DELTA PRE-SHIP REVIEW REQUEST FOR ACTION NO. 1

Project: **EOS**
Spacecraft/Observatory: **Aura**
Instrument: **HIRDLS**

REVIEW **Delta Pre-Ship Review**
Date: **21 November 2002**

SUBJECT: HIRDLS Delta Pre-Ship Review (DPSR) RFA #5 Response

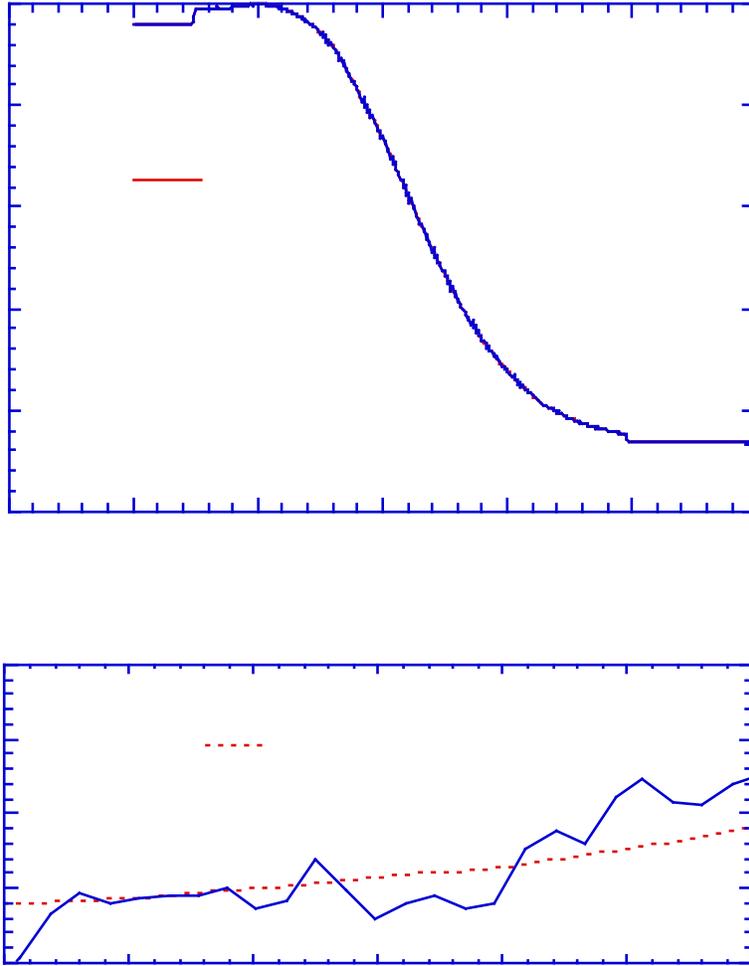
- 1) Request: Provide a technical note on the science impact of the jitter phenomenon seen at Oxford. Also include jitter amplitude and frequency thresholds where science is impacted.
- 2) Request: Describe what testing and/or analysis will be done at TRW with HIRDLS mated to the Observatory that will assure us that the jitter phenomenon is not a concern for flight.
- 3) Request: Describe if/how jitter can be measured on-orbit.

Therefore the fractional error term is just $B^{-1}(z)(\beta^2/4)d^2B/dz^2$. Since $d^2 \ln(B)/dz^2 \sim (1/H)^2$, where H is the scale height, we have that the fractional error in the radiance is $\sim(\beta/2H)^2$. For $\beta = 50$ meters and $H = 6$ km, this has a numerical value of 1.7×10^{-5} , totally negligible in relation to our required precision of 0.5%. Thus in the global mode, the jitter would have to reach 1200 meters p-p, or 80 arcsec p-p, to make an error of 0.25% in the measured radiance, the level at which it would begin to have an impact on the science.

To verify these calculations, we have run simulations with the HIRDLS Radiometric Model (HIRAM). We used channel 2, one of the temperature sounding channels, because these have the highest precision requirements. We simulated the generation of the measured radiance profile at global scan rate for the standard HIRDLS fiducial radiance profile, using specified detector noise and no jitter; then we ran the simulation again with a jitter term added to the pointing with a p-p amplitude of 140 arcsec p-p, a factor of 28 greater than observed at Oxford, so that the offset errors, 780 times larger than for 5 arcsec, as indicated above, would be large enough to see. The difference in the simulated measurements is shown, along with the radiance profile in Fig. 1. Note that as expected, the effect, as a percent of signal, is largest at the altitude where the radiance profile is changing most rapidly. The error is about 0.45% at 53 km. Scaling the result to 5 arcsec of jitter, the error is 0.0006% of the signal at an altitude of 53 km; this error is only 0.01% of the measured radiometric noise. Both of these values have a negligible science impact.

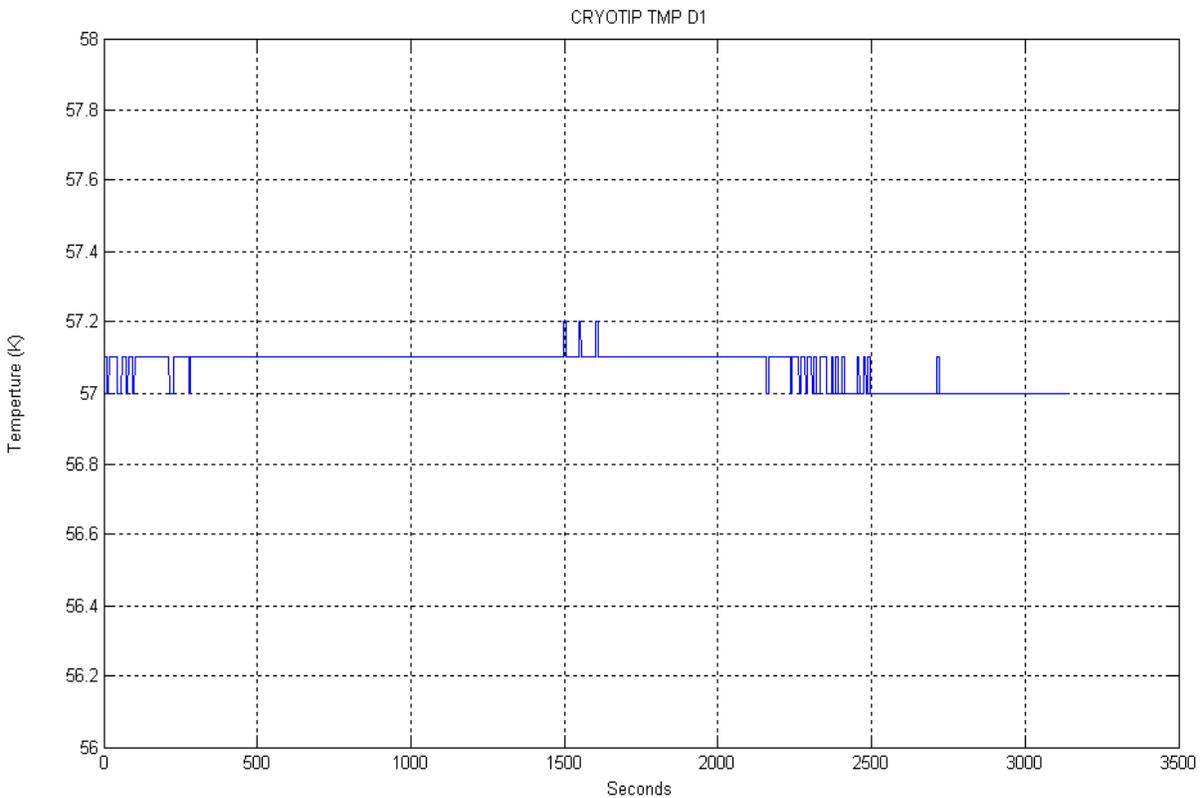
What is the plan for using the D0 cryodiode? Shouldn't it be declared a failed part and replaced with D1 as primary?

D0 cryodiode showed a step function at LM. It has also shown some instabilities during calibration at Oxford. In my opinion D0 should not be counted on for inflight operations, not even as backup. This should be addressed to the program office, not a calibration issue.

Use as is with the D1 sensor channel as primary and with appropriate operational workarounds in hand should the D1 channel fail in flight.

The graph below shows the cryotip temperature as sensed by D1 over a 53 minute period on day 2002_310; the cooler stroke was manually set to a constant value over this period. Note that the cryotip temperature remained constant over this period to within \pm one quantization level (0.1 K), which is as good as can be achieved with CCU closed loop control.

Figure X. Single Side of BEU Electronics On Assembly Fixture Before Folding. Assembly requires careful folding of analog wiring between boards and inductors.

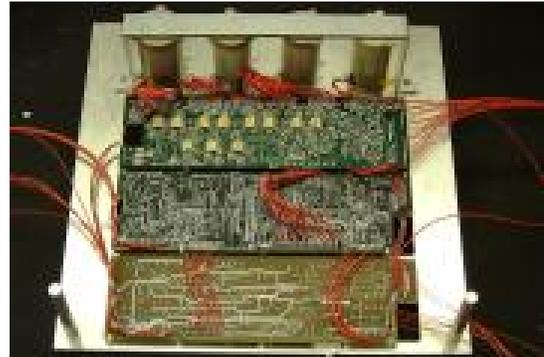
For the HIRDLS In Flight Calibrator (IFC) Telemetry Jumps, determine the root cause. If a design problem is confirmed to be the root cause, as has been postulated, implement the appropriate circuit fix and retest as required or explain how the IFC can be used as is (i.e. what viable work-arounds can be implemented if both IFCs were to develop glitches on orbit).

The IFC successive approximation logic design implementation uses combination logic outputs to control flip-flops. Dependent on timing, it appears that this design approach can be prone to "glitches". It is not apparent that the observed glitching, although so far only seen on the "A" side and at ambient pressure conditions, could not possibly shift with normal on-orbit factors including part aging, cumulative radiation dose, and voltage variations such that the effect might worsen, occur in the instrument normal operating range, and possibly occur on both the A and B sides. It appears that a hardware fix for this ultimately most likely will be needed if it is verified that the telemetry jumps are the manifestation of a fundamental design issue, since such glitches will be most likely not be able to be successfully characterized with any degree of certainty. A digital deglitching circuit fix, if implemented, would in itself not seem to be an issue that would necessitate instrument re-calibration. This is most important and should be verified ASAP. An appropriate circuit fix could be relatively simple, and should to be requalified through component-level testing. The problem was seen in instrument ambient testing, so extended ambient testing at the instrument level coupled with normal observatory integration and testing should be adequate to confirm the fix when coupled with a full box-level test. The issue of instrument disassembly, reassembly, and penalty testing would, however, need to be addressed dependent on the level of difficulty in IFC removal and replacement.

The HIRDLS Team recommends not opening the instrument and investigating the IFC temperature telemetry anomaly. The question is a balance of risk. Since the work would be very invasive involving:

Through that process, any number of problems could arise (damage to the wiring) affecting impedance, continuity, which could manifest as a missing bit over the range of the bridge for example. The interior of the BEU is very tight and the analog wiring is very sensitive (see Figure X and Figure X). The BEU-BB cable is most fragile and it's impedance could change with poor handling.
